3/31/2015
OFFICIAL NOTICE NO. 46

ADDENDUM NO. 1

Official Notice No. 46
Century City Redevelopment Project, Area A/Zone #1
North End Improvements
3945 North 31st Street
Milwaukee, WI

Century City Redevelopment Project Area A/Zone #1
North End Improvements
3945 North 31st Street, Milwaukee, Wisconsin
Department of Public Works Official Notice # 45
And
Century City Redevelopment Project Area A/Zone #1
Monument Sign Fabrication and Installation
3945 North 31st Street, Milwaukee, Wisconsin
Department of Public Works Official Notice # 46

F PIPE REMOVAL DETAIL

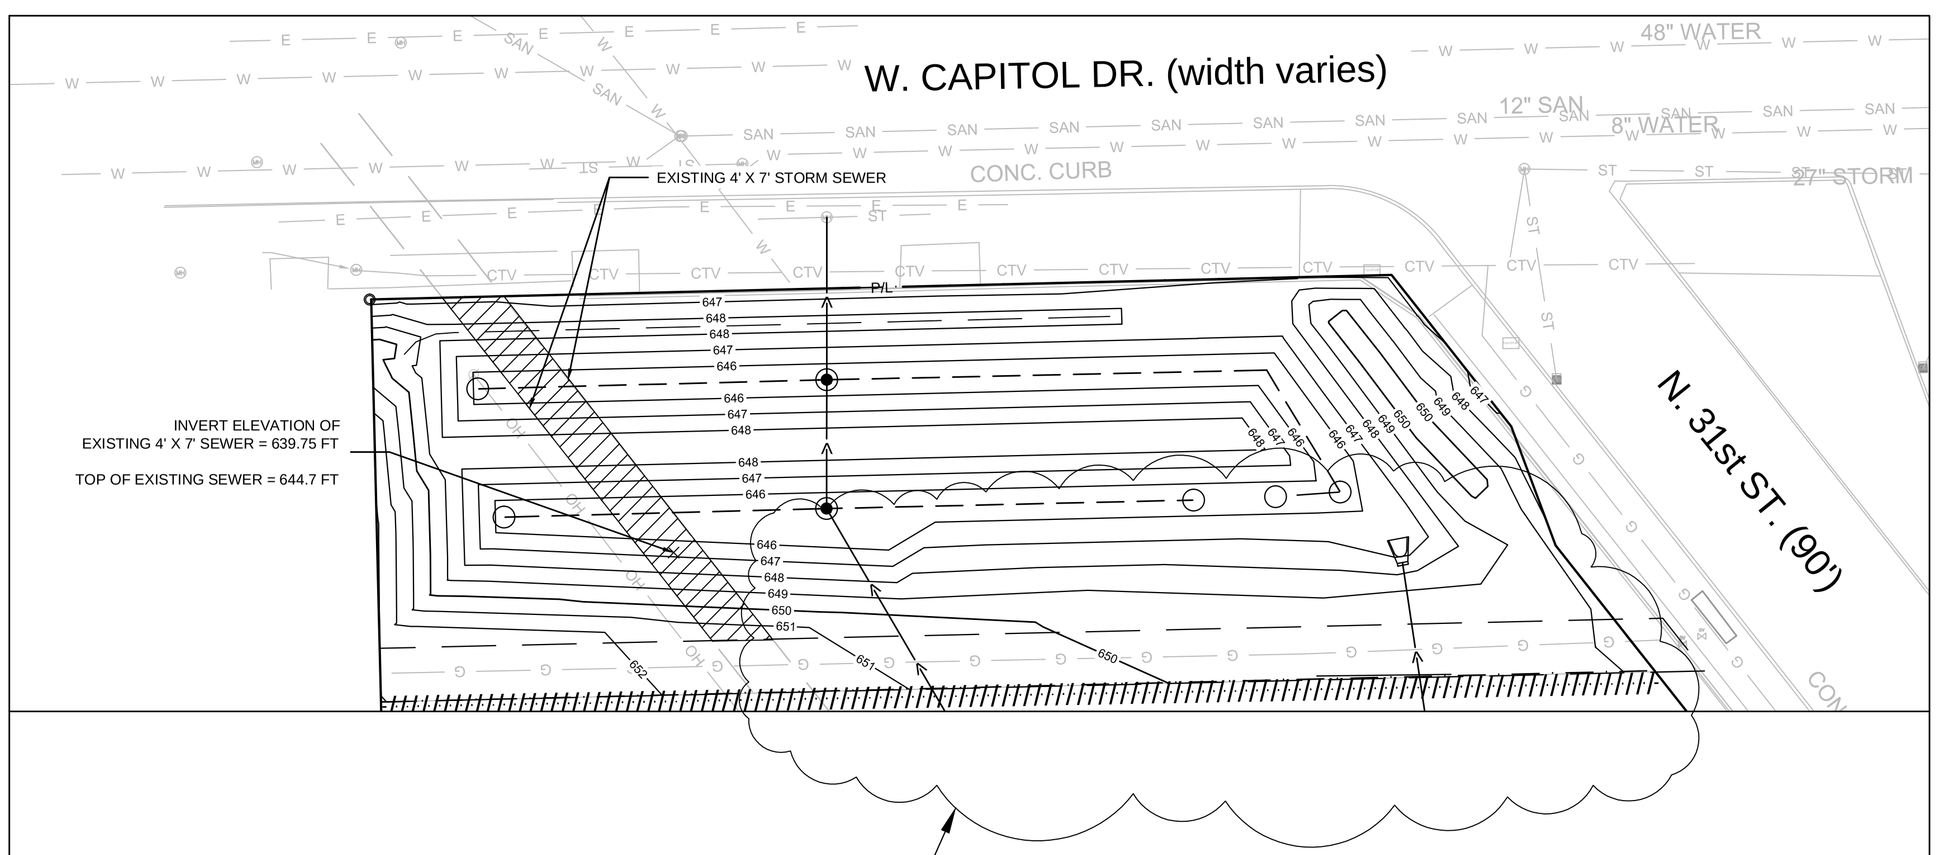
Q6: What will the contractor need to do with respect to the abandoned box sewer?

A6: The box sewer will be filled with slurry prior to the contractor beginning work on the north end improvements project. It will be the contractor's responsibility to excavate and remove sections of the sewer and slurry in order to achieve the proper grades shown in the biofiltration plans.

BIOFILTRATION AREA LANDSCAPE PLAN

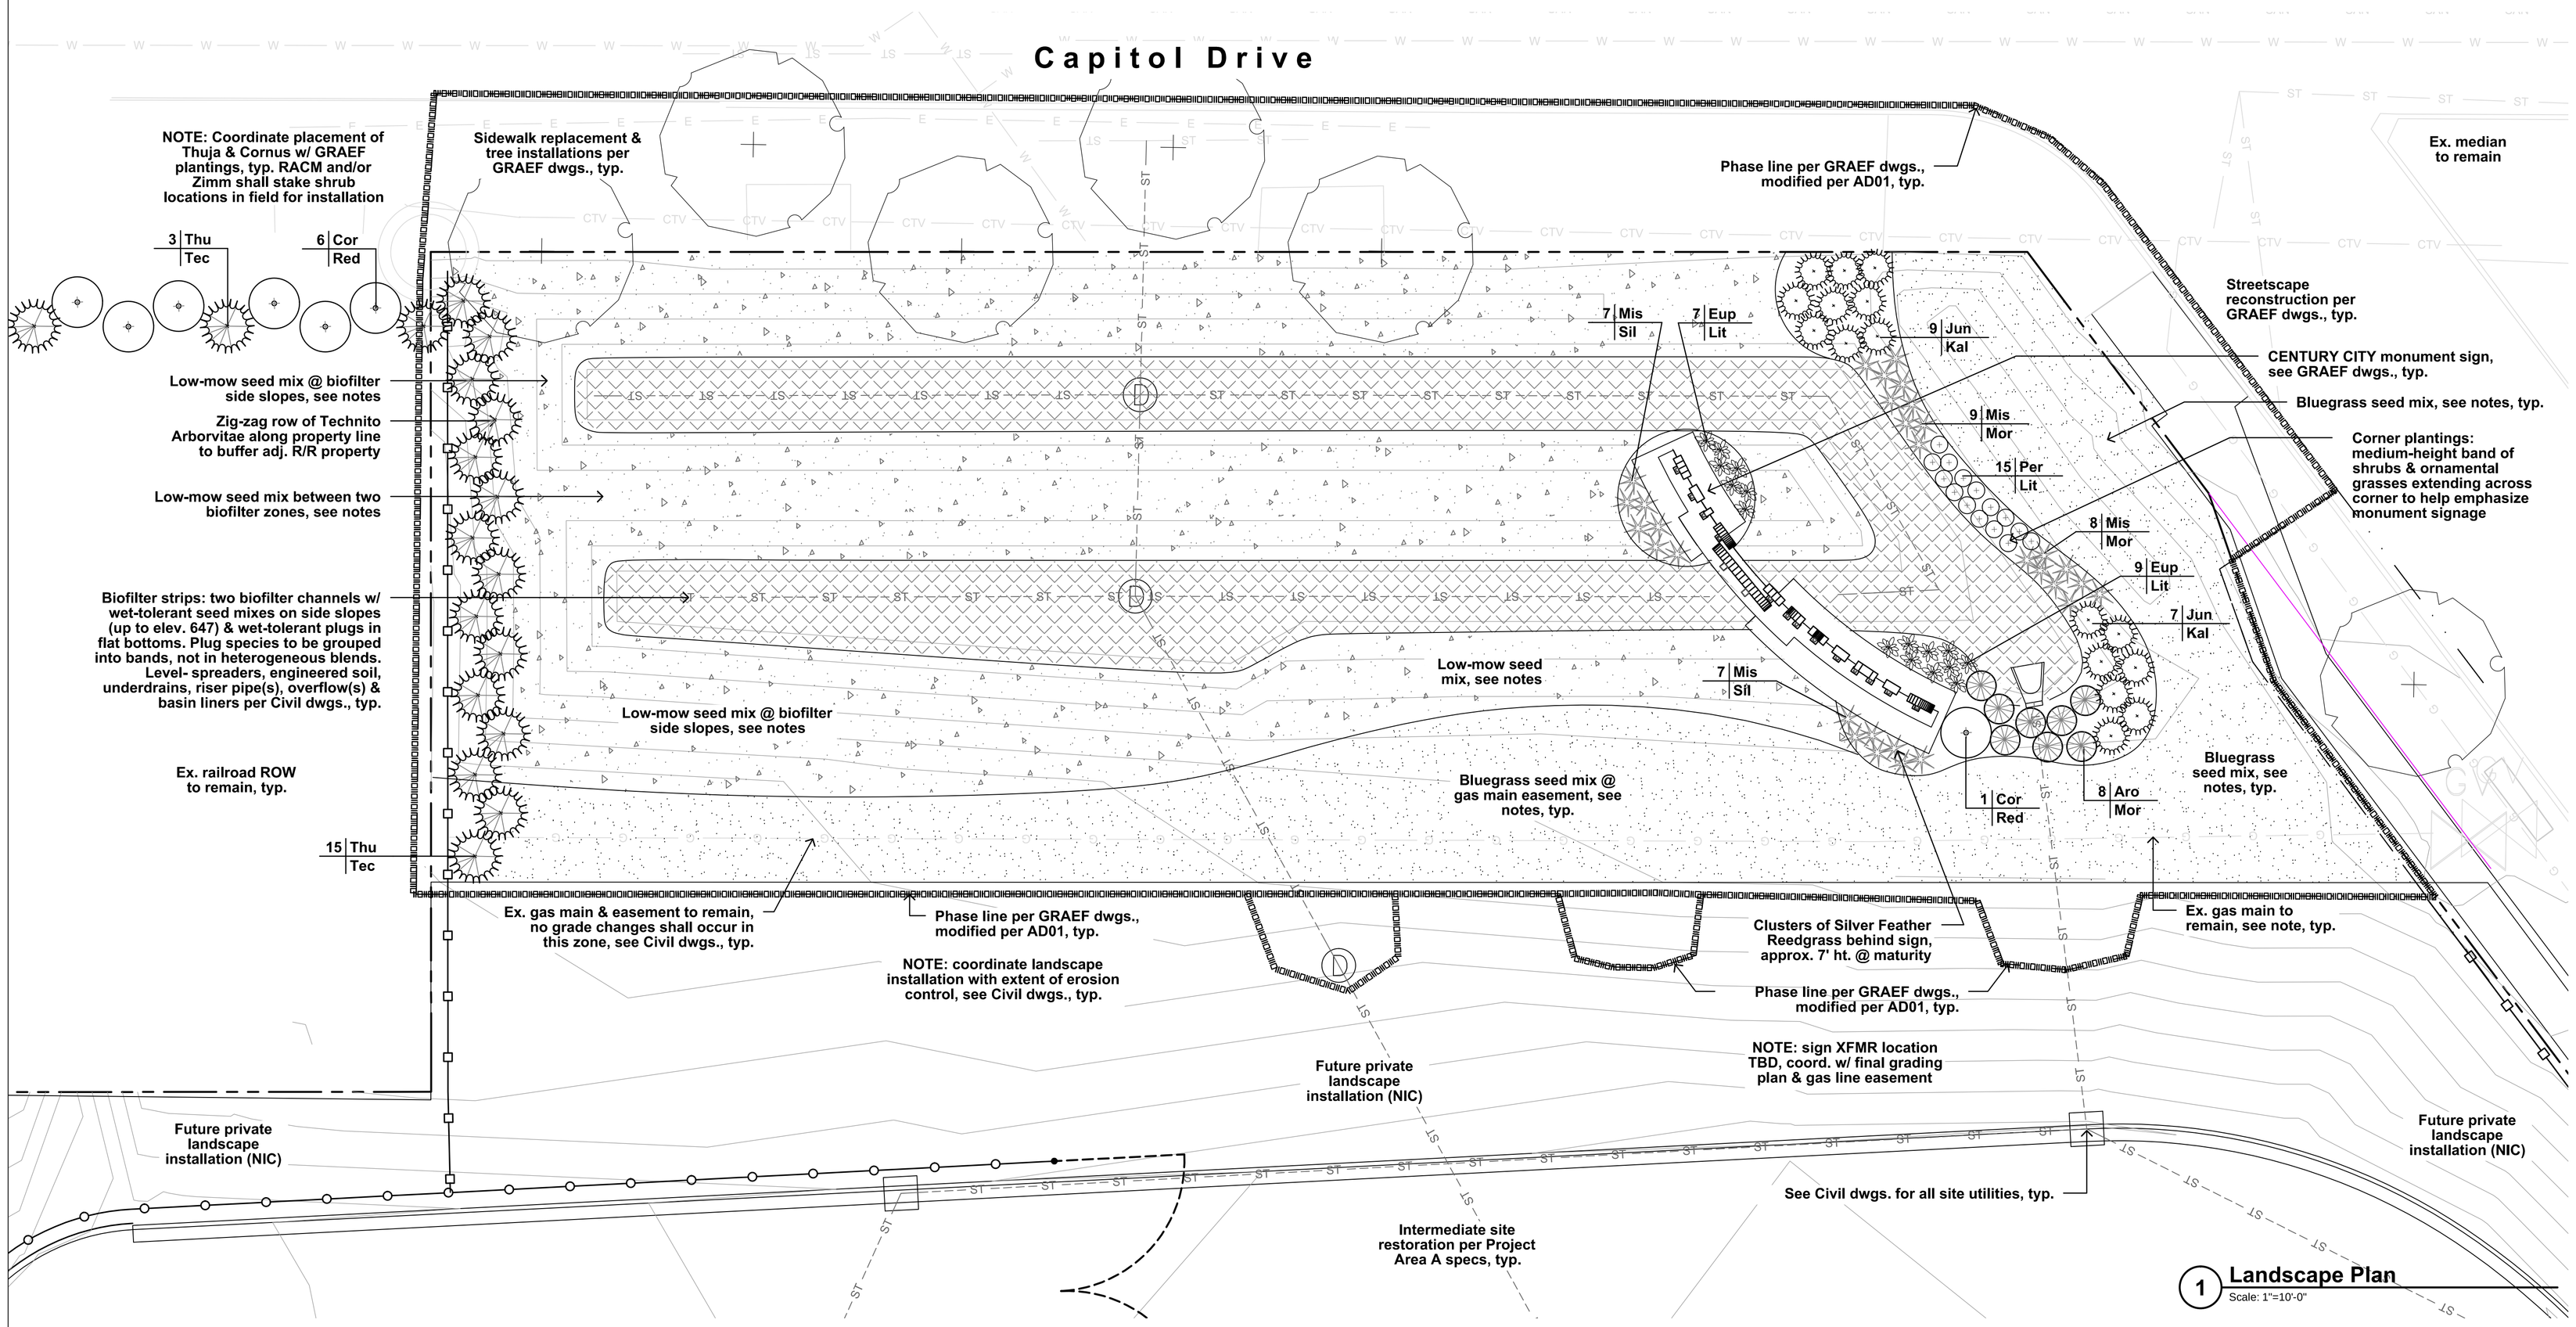
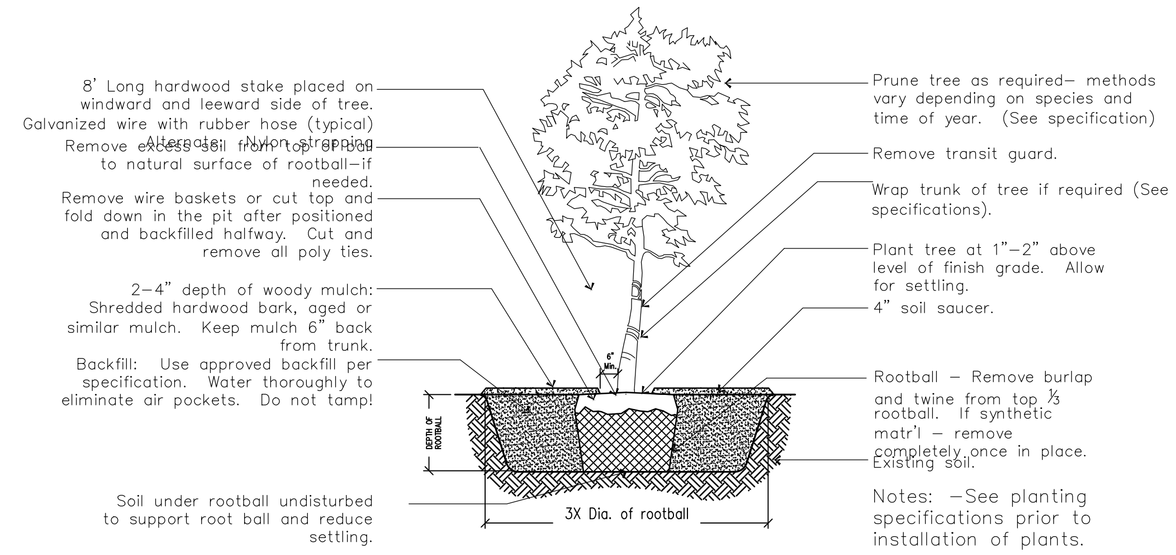
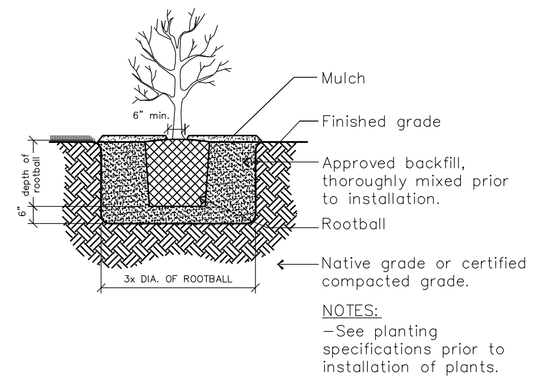
Q4: Which plan sheets show the outfall design?

A4: The landscape design around the outfalls is included in the Zimmerman plan sheets L100 and L500 which were omitted from the original bid package, and are now included in this addendum.
